Re: Response to Initial Submission Review - 38th Extension Between Himalaya Rd and Odessa St - Site Plan
Application Number: DA-1127-49
Case Numbers: 2023-6057-00

38TH AVENUE
INFRASTRUCTURE SITE PLAN
LOCATED IN SECTION 26, TOWNSHIP 3 SOUTH,
RANGE 66 WEST OF THE 6TH PRINCIPAL MERIDIAN,
CITY OF AURORA, STATE OF COLORADO

38TH AVENUE WIDENING
INFRASTRUCTURE SITE PLAN
TITLE: COVER SHEET

38TH AVENUE WIDENING
INFRASTRUCTURE SITE PLAN
TITLE: NOTES & TYPICAL SECTIONS

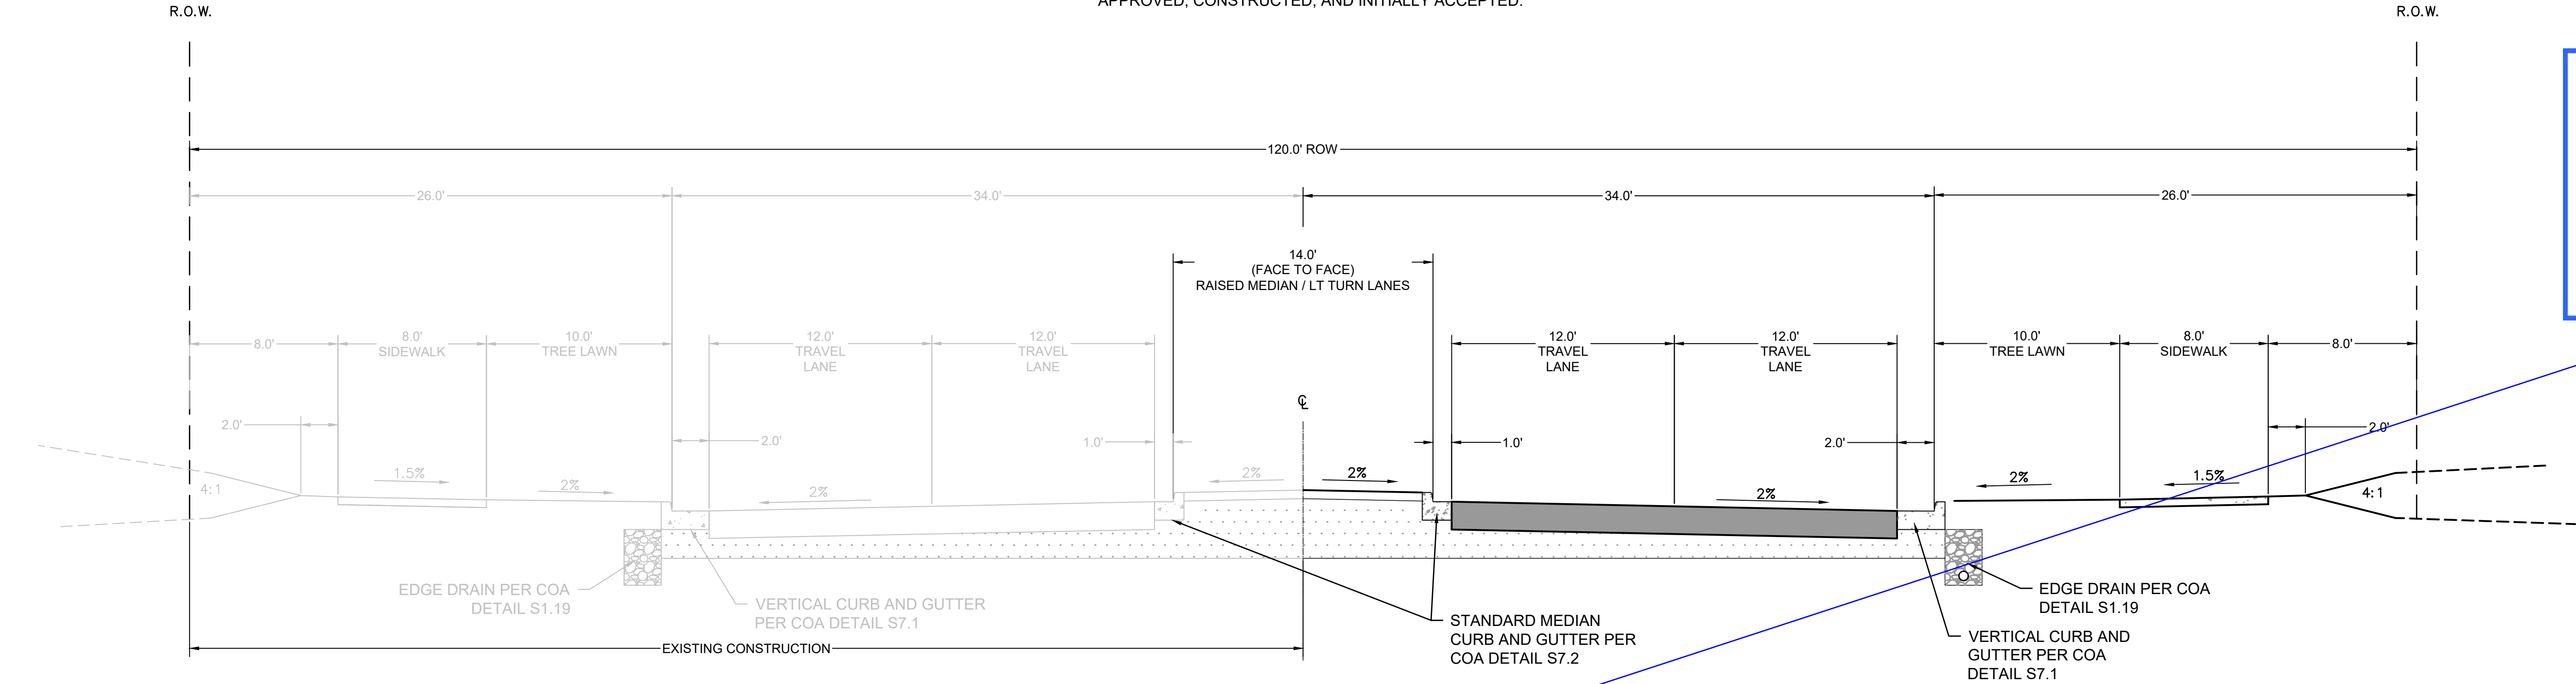
Add hydrant in this street section. Use notes provided.

Hydrant added to proposed half of typical section.

SHEET:03 OF 10

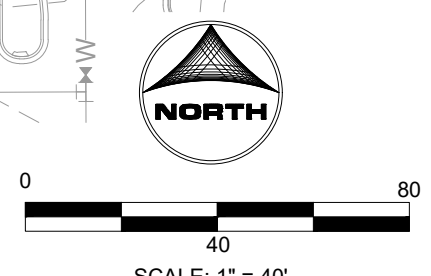
Please add these additional notes to the Roadway Site Plan sheets.

Type and height designation added to note. Type and height matches what was built in the north half.

Added.

Notes added.

SHEET: 05 OF 10

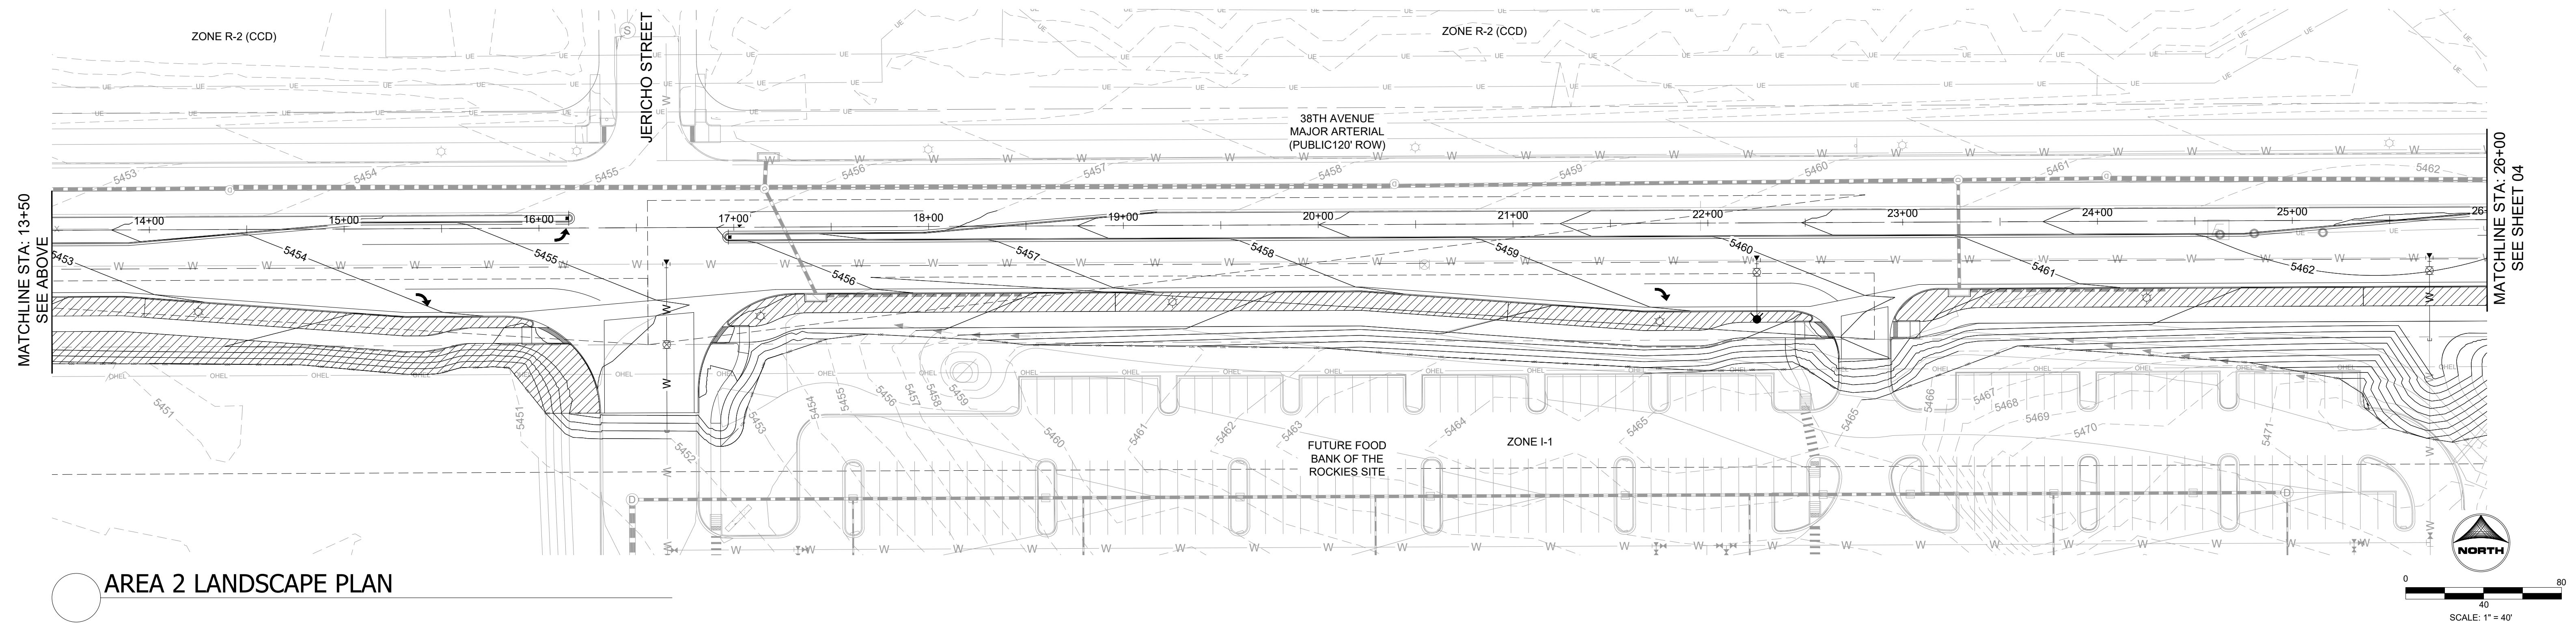
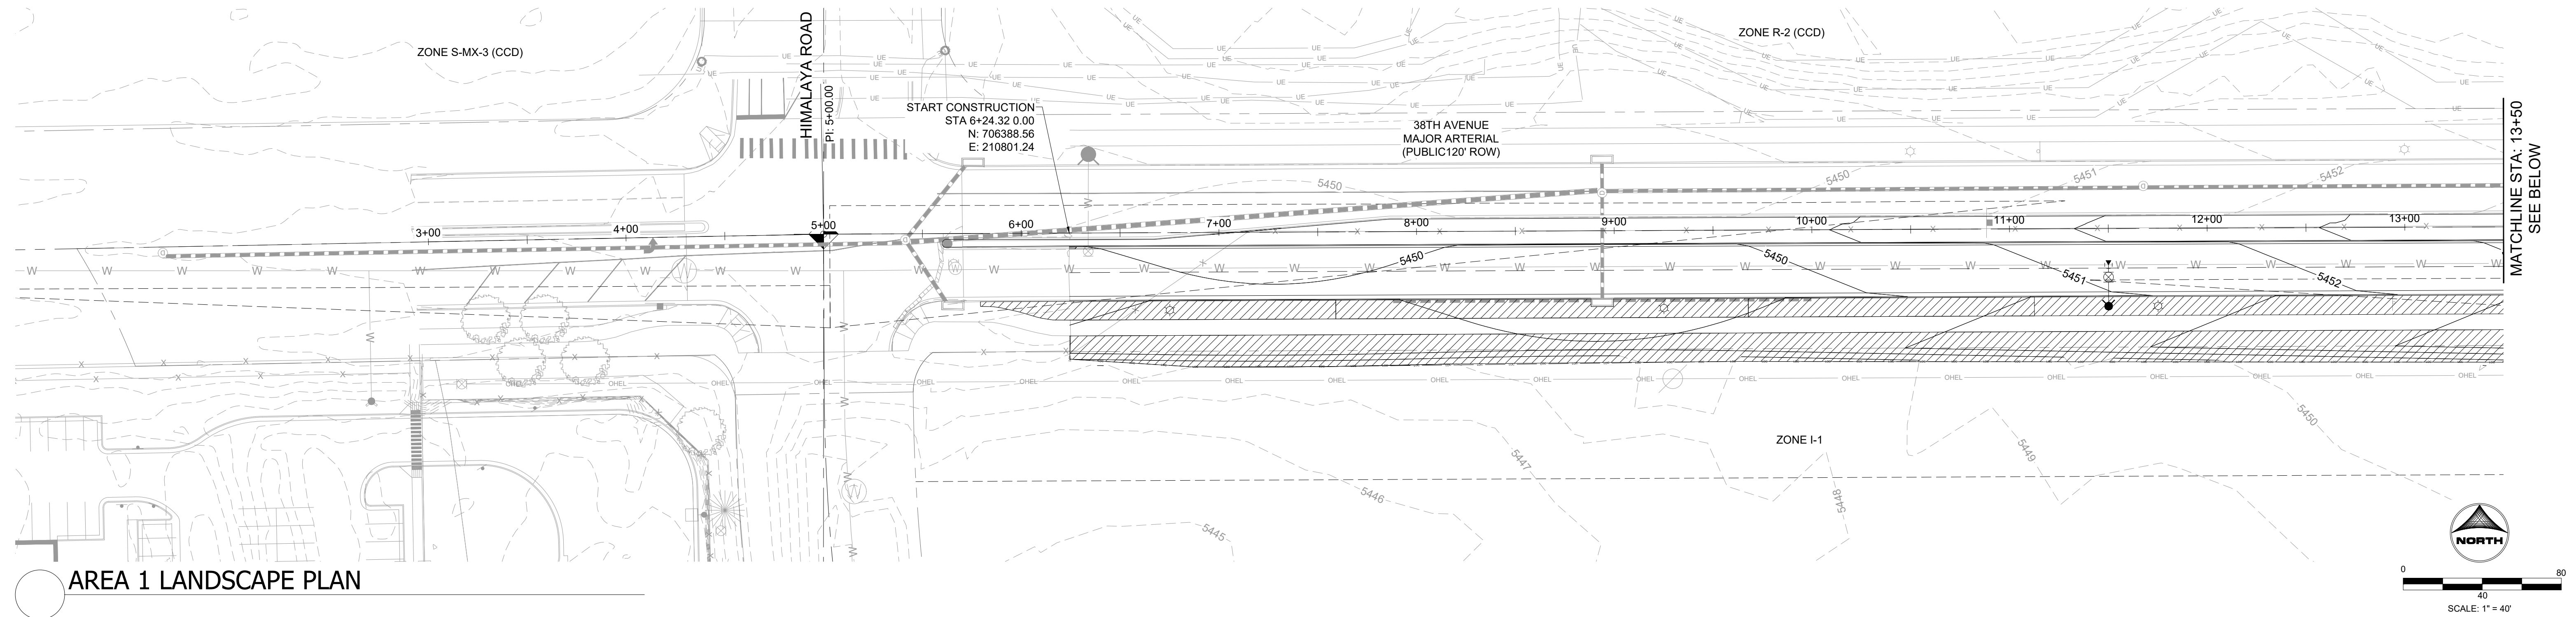
- 8A. Update the landscape plan to include an updated base with lighting, Several poles are missing and/or turned off on the landscape plan sheets.

- 8D. If it is possible to shift the fire hydrant in the Area 1 Landscape so that the tree can remain, that would be best.

Response: Light pole line weight has been adjusted and are now showing

Response: Fire hydrant location has been adjusted
